LCV-0606

VOGTLE ELECTRIC GENERATING PLANT
UPDATED DOCUMENTATION FOR LICENSE AMENDMENTS APPLICATION
SOUTHERN NUCLEAR TO BECOME THE LICENSED OPERATOR
NRC TAC Nos. M84531 and M84532

**Updates to Application to Amend
Facility Operating License Nos. NPF-68 and NPF-81
dated 9/18/92**

Southern Nuclear Operating Company **

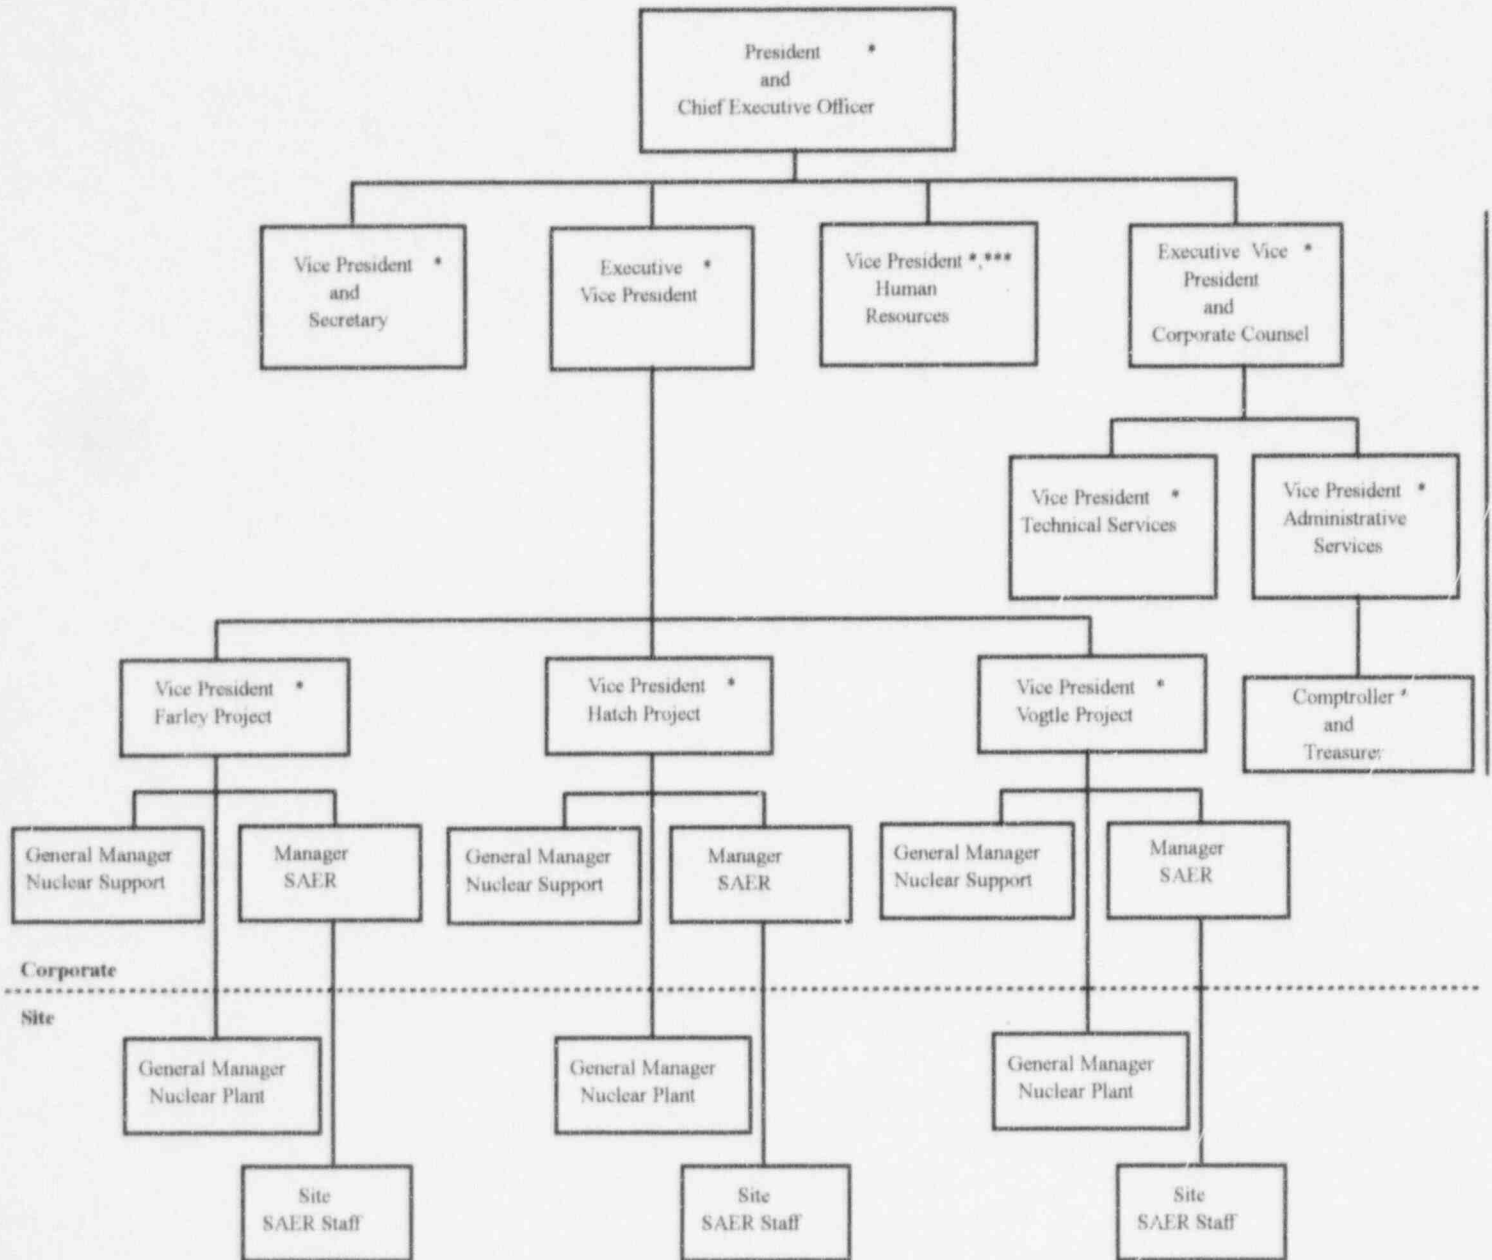
2. A change was made to the proposed organizational chart on page 9. The Governmental Affairs position was replaced with the Executive Vice President and Corporate Counsel position. With this change, the Technical Services and Administrative Services Vice Presidents now report to this new position.

3. A change was made to the proposed organizational chart on page 9. Due to the Southern Company functionalization of some Human Resource duties, an additional Vice President - Human Resources position was added. This Vice President has additional reporting responsibilities to other Southern Company subsidiaries.
